HISTORIC AND DESIGN REVIEW COMMISSION

HDRC CASE NO: 2017-114
ADDRESS: 435 CEDAR ST
LEGAL DESCRIPTION: NCB 2968 BLK 3 LOT A9
ZONING: RM-4
CITY COUNCIL DIST.: 1
DISTRICT: King William Historic District
APPLICANT: Alex Mata
OWNER: Alex Mata
TYPE OF WORK: Modification of existing COA, garage extension, material changes
REQUEST:

The applicant is requesting a Certificate of Appropriateness for approval to make amendments to a previously-approved Certificate of Appropriateness. These amendments include:

SITE PLAN - PROPOSED

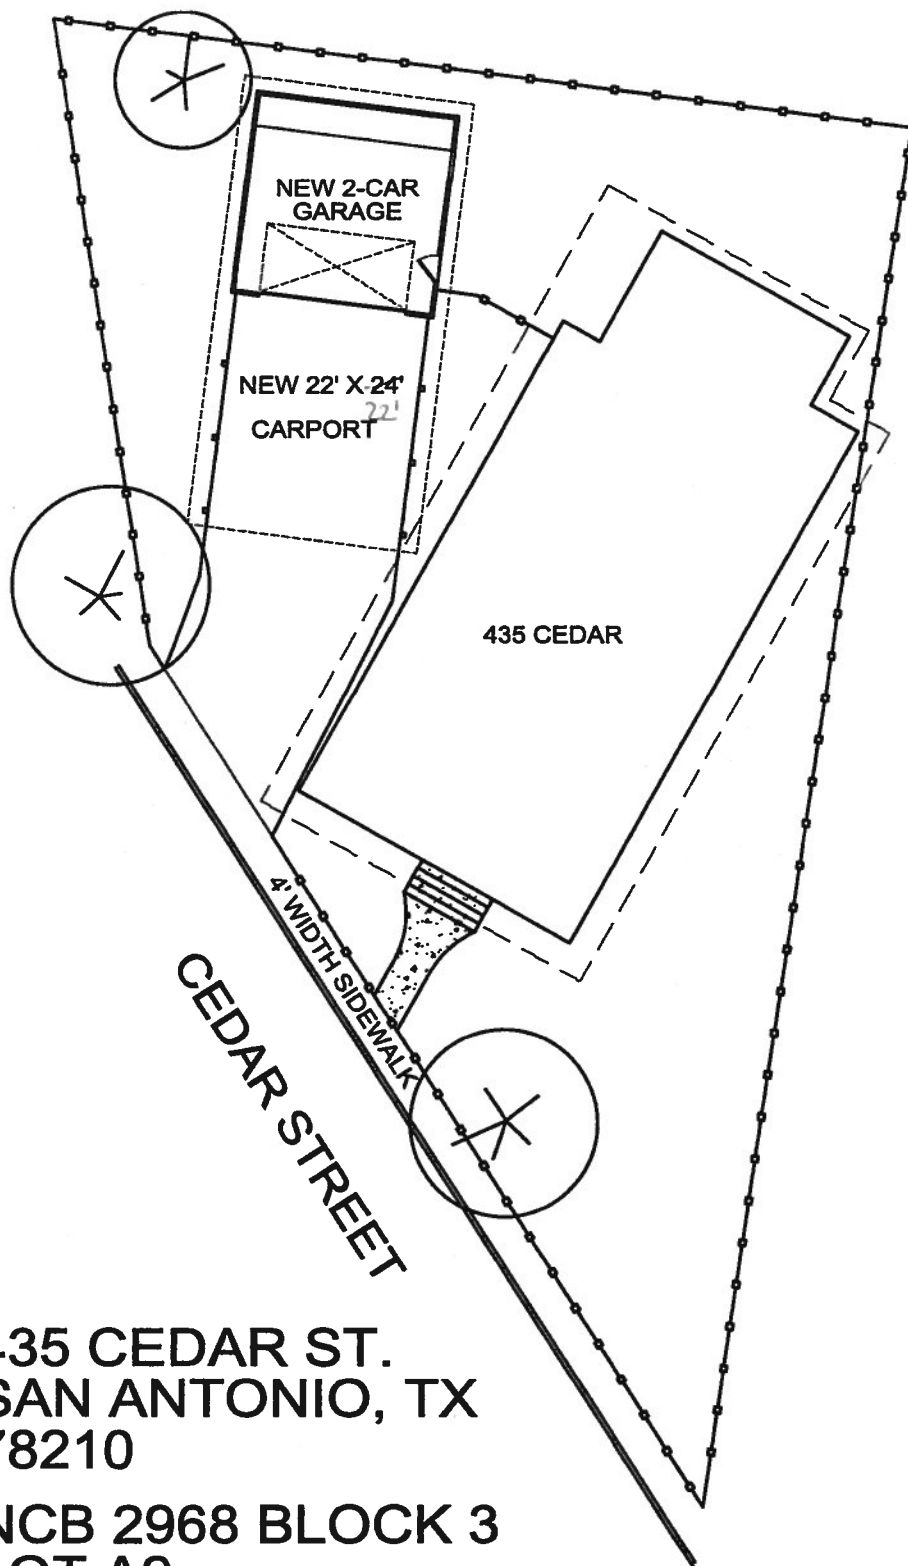
- b. BUILDING SIZE – According to HDRC Case 2016-420, the applicant’s original proposed accessory structure was approximately 485 square feet, with a carport area that will cover approximately 530 square feet. The structure and carport total more than forty (40) percent of the existing structure, but the proposal was a reduction in size and massing relative to the original accessory structure that was approved for demolition. The extension of the structure by two (2) feet into the carport area will not drastically alter the massing and is acceptable.

1. Staff recommends approval of the proposed extension based on finding b with the stipulation that the carport's Craftsman details be re-proportioned to match the original proposal.
2. Staff does not recommend approval of the proposed metal garage door based on finding d.
3. Staff recommends approval of the roof material change based on finding c with the stipulation that the roof color and finish match that of the primary structure.
4. Staff does not recommend approval of the door and window material change based on finding e.

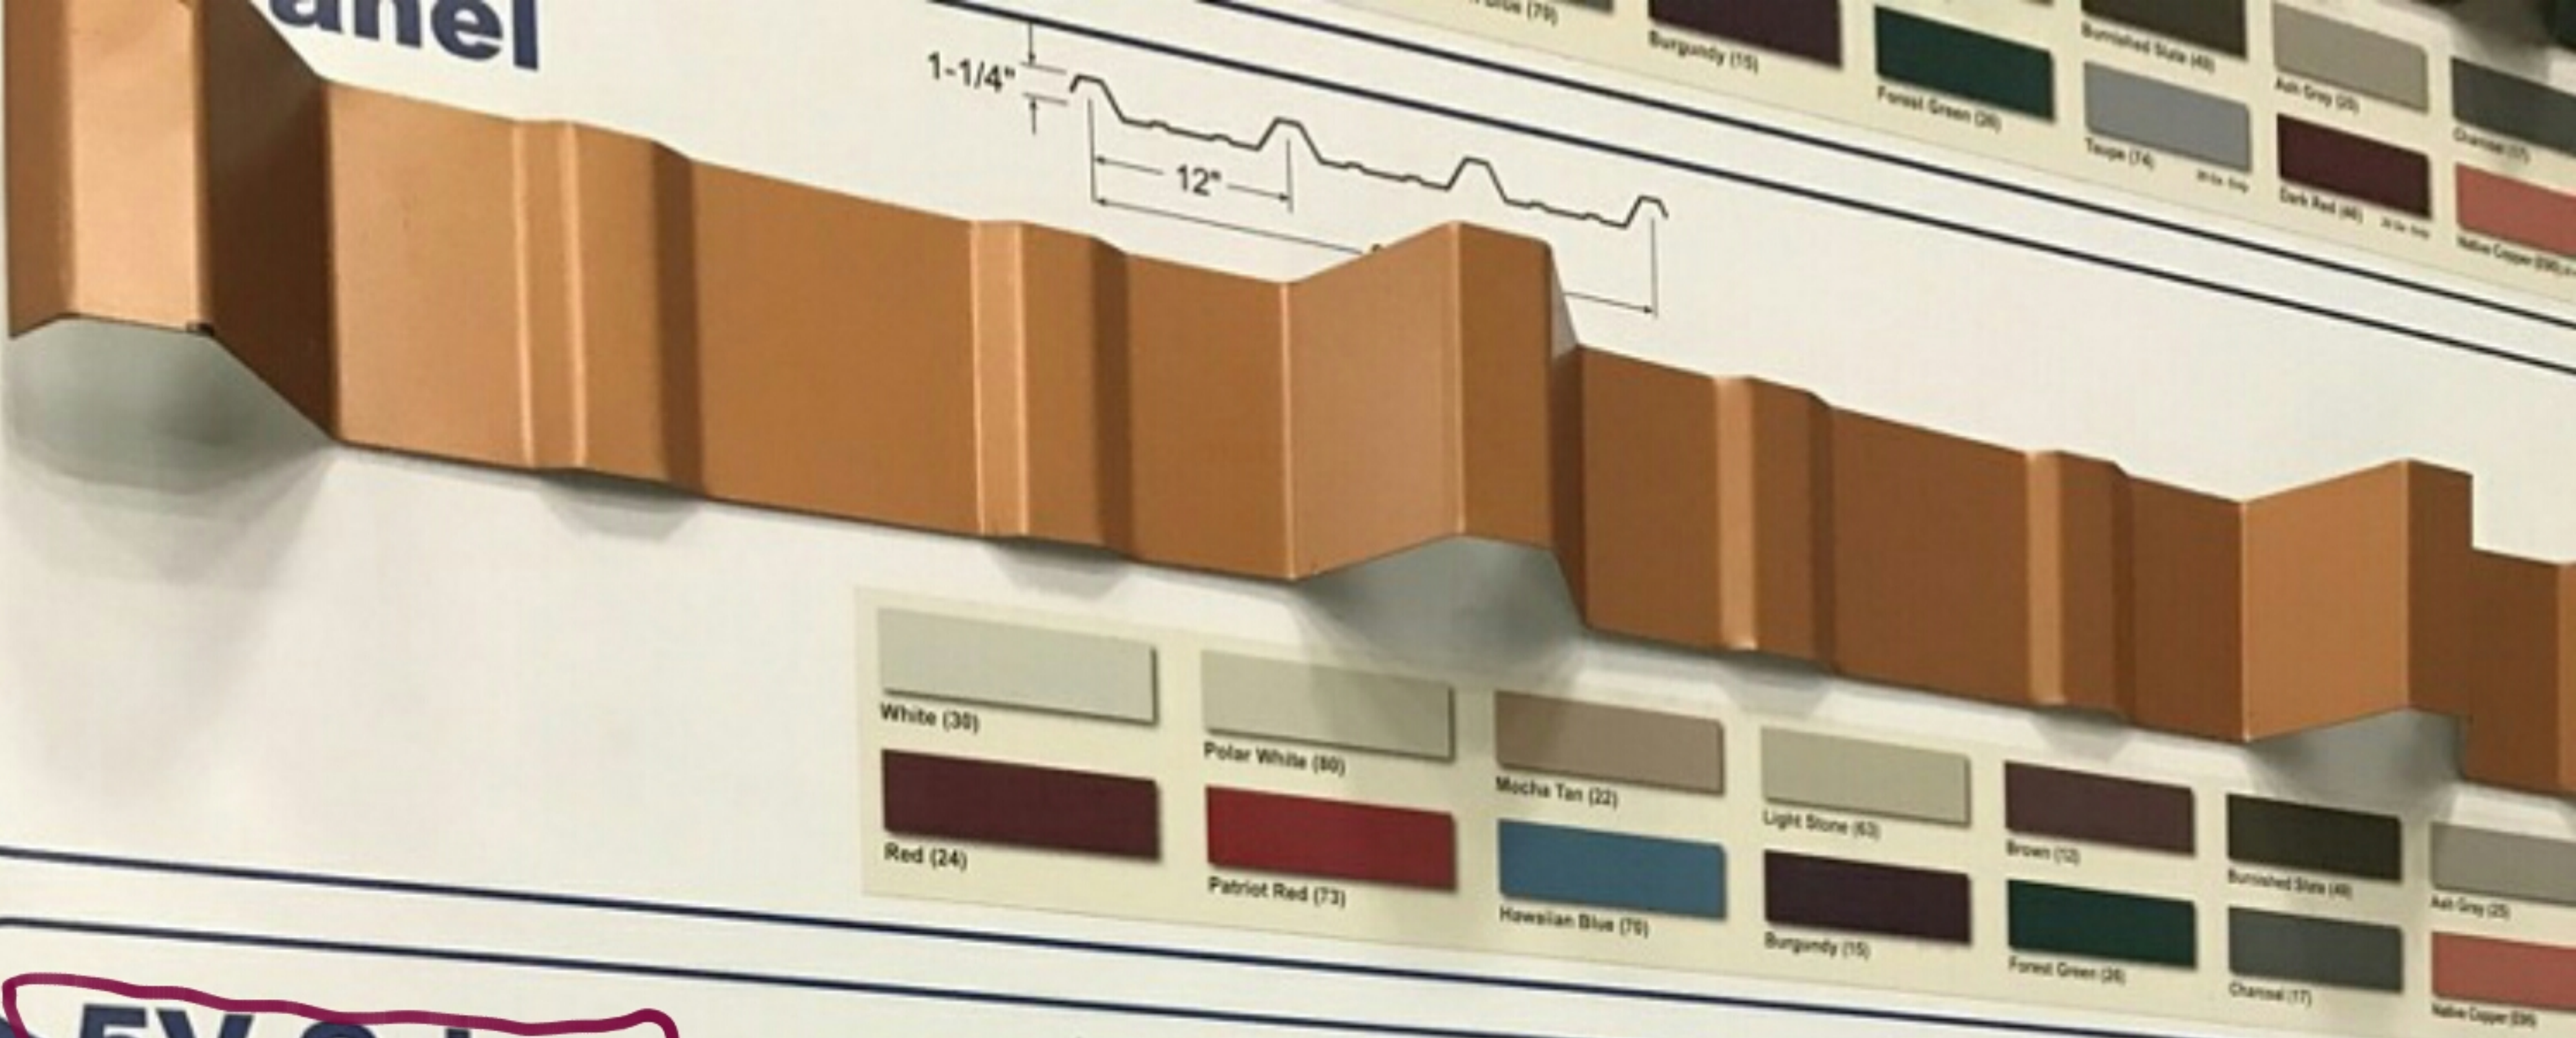
- d. GARAGE – The applicant’s HDRC Certificate of Appropriateness issued on November 2, 2016 stipulated that a wood garage door or wood carriage door be used in lieu of the originally-proposed metal panel garage door. Staff finds this original stipulation to be appropriate and does not recommend the use of a metal panel garage door in the King William Historic District per guideline 5.A.v.

5V-Crimp

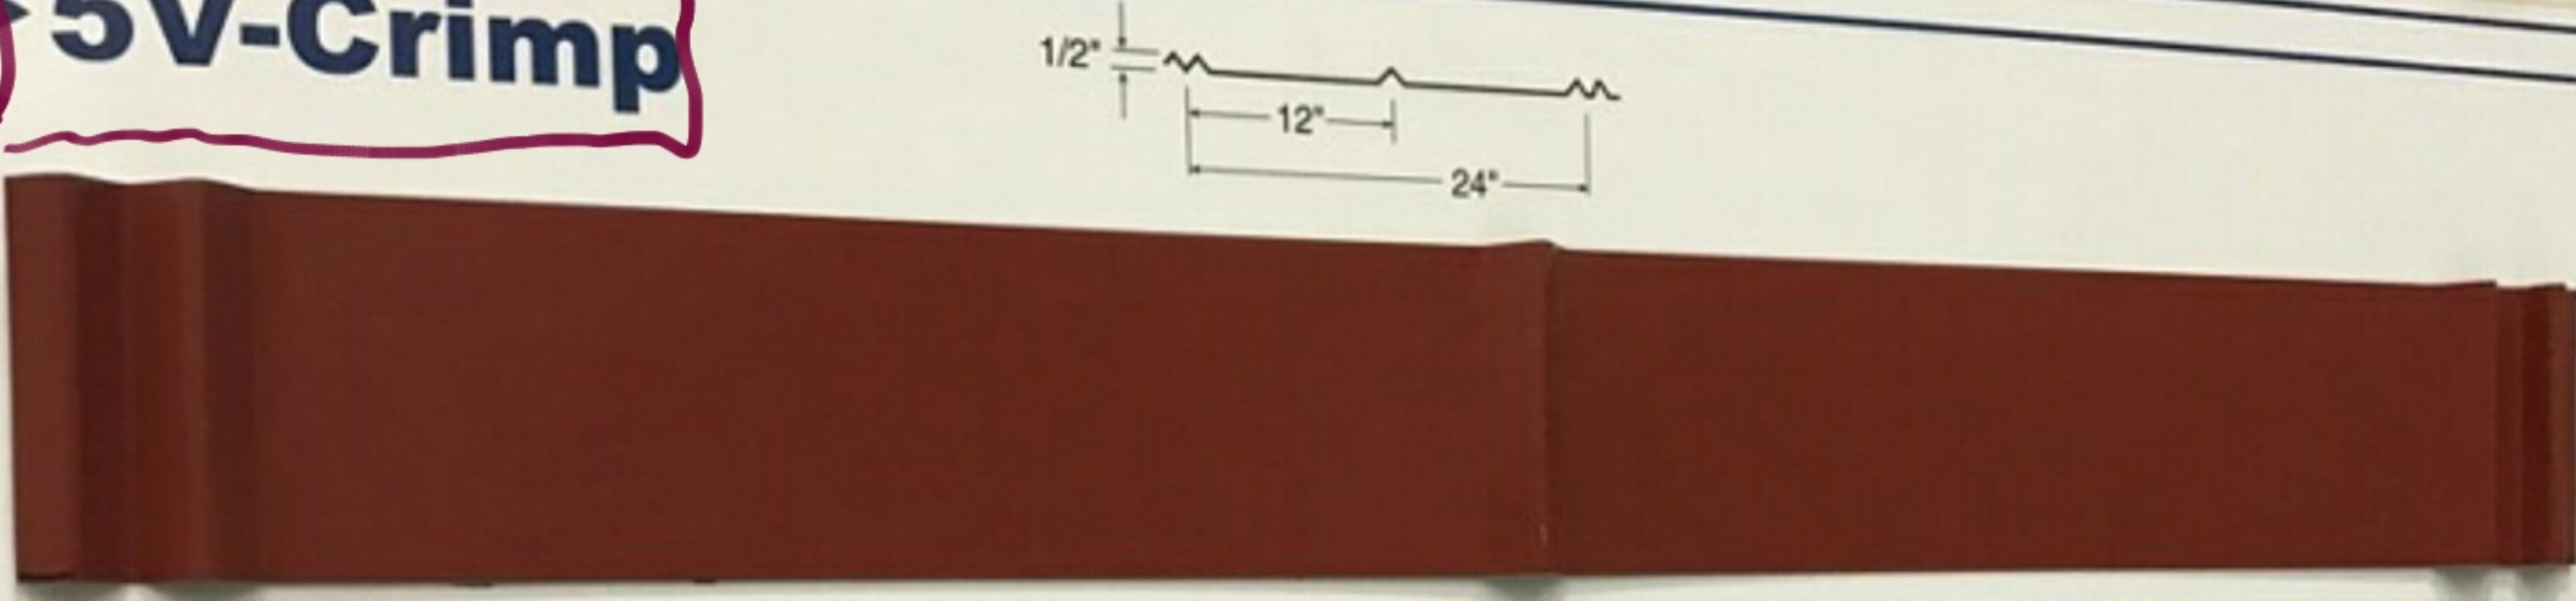
- c. ROOF – According to the Checklist for Metal Roofs, the applicant’s proposal to install a 5V-crimp 26 gauge galvanized with low-profile ridge cap is acceptable. However, the use of modern manufacturer’s colors is not recommended. Staff recommends that a standard galvanized finish be used.

36" METAL
6 PANEL
DOOR

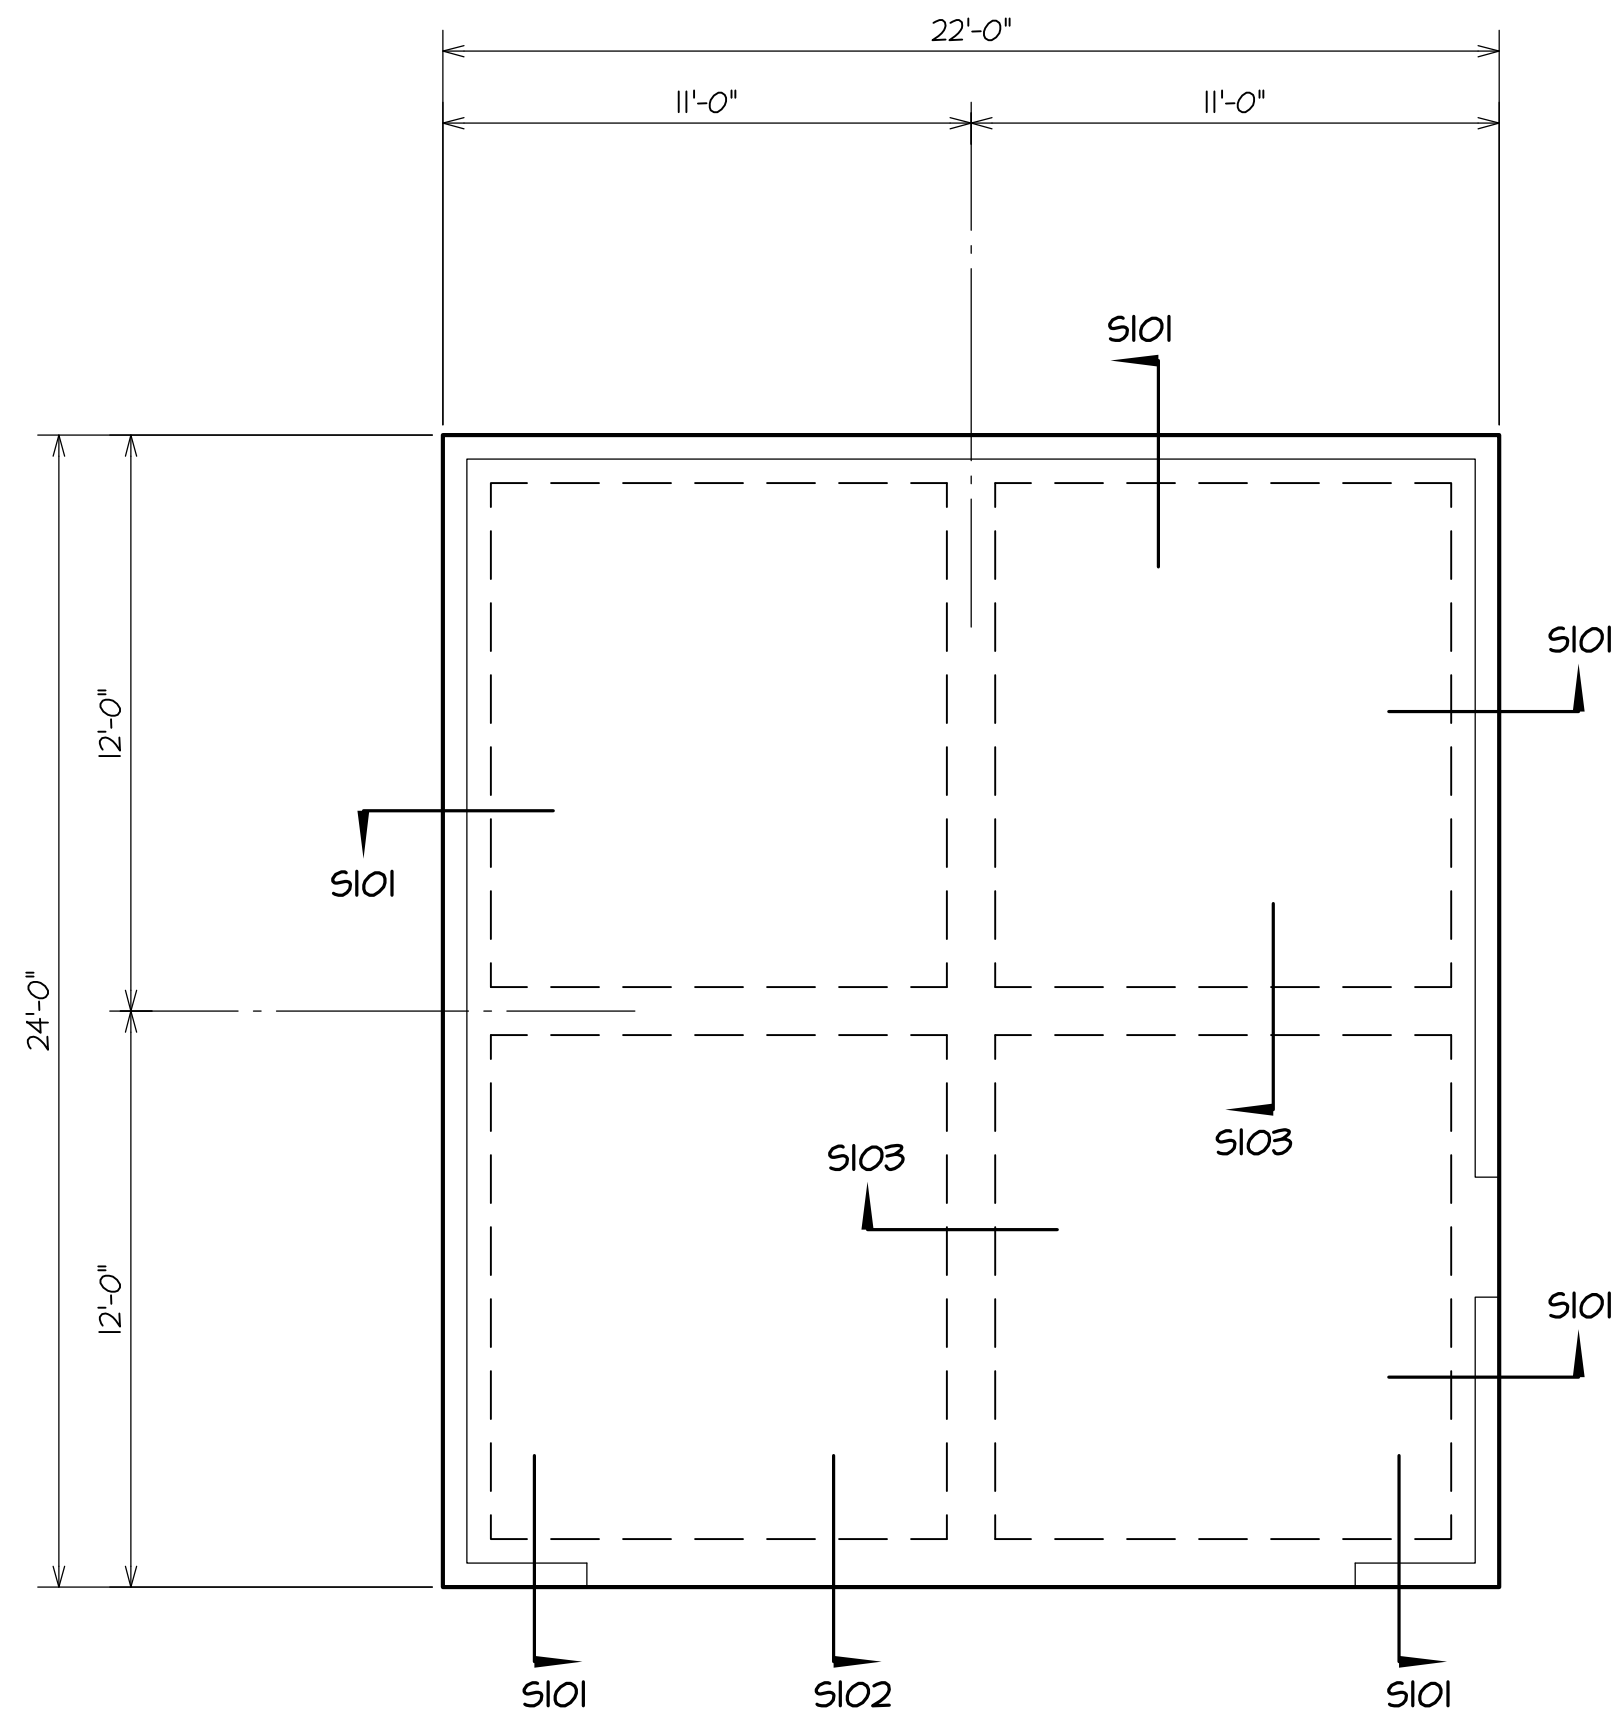
- e. WINDOW AND DOOR – The guidelines for garages and outbuildings recommend materials complementary to the primary structure as well as the district. Staff does not find the use of a metal door or window in lieu of wood to be appropriate.
